Technical Service Bulletin

MODEL(S) AFFECTED: Tennant 6600, 6650, 7400, 8200, 8210, M20 (**ONLY** machines equipped with GM 1.6L LP engines)

SUBJECT: Vaporizer freezing, causing the engine to shut down. The engine will restart when the vaporizer defrosts, but will shut down when the vaporizer refreezes again while the engine is running.

FIG. 1

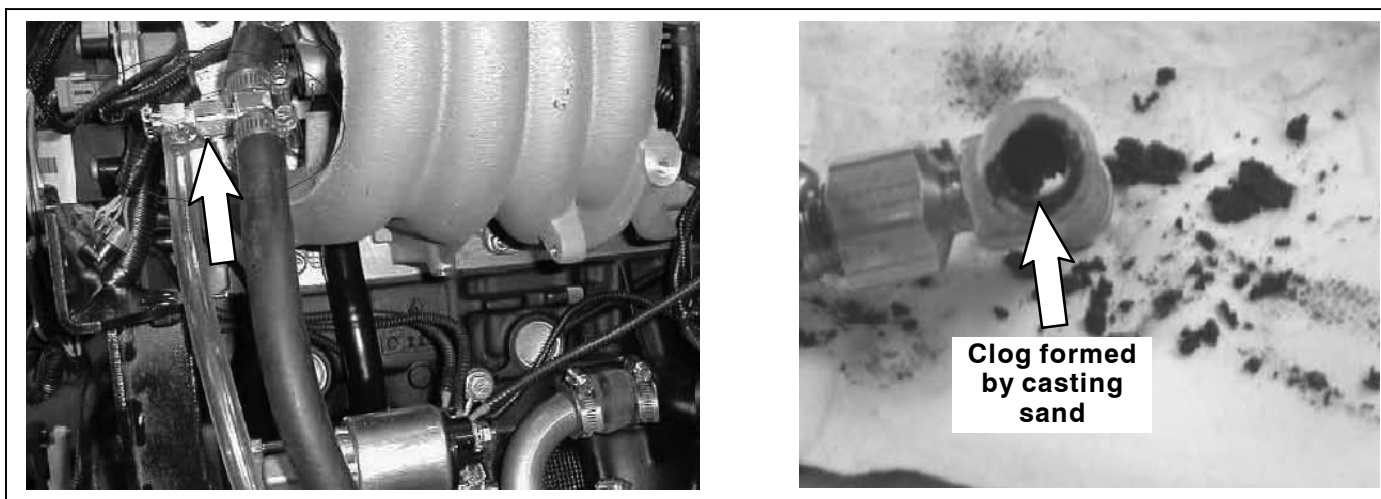
Refer to Page 2 for part locations
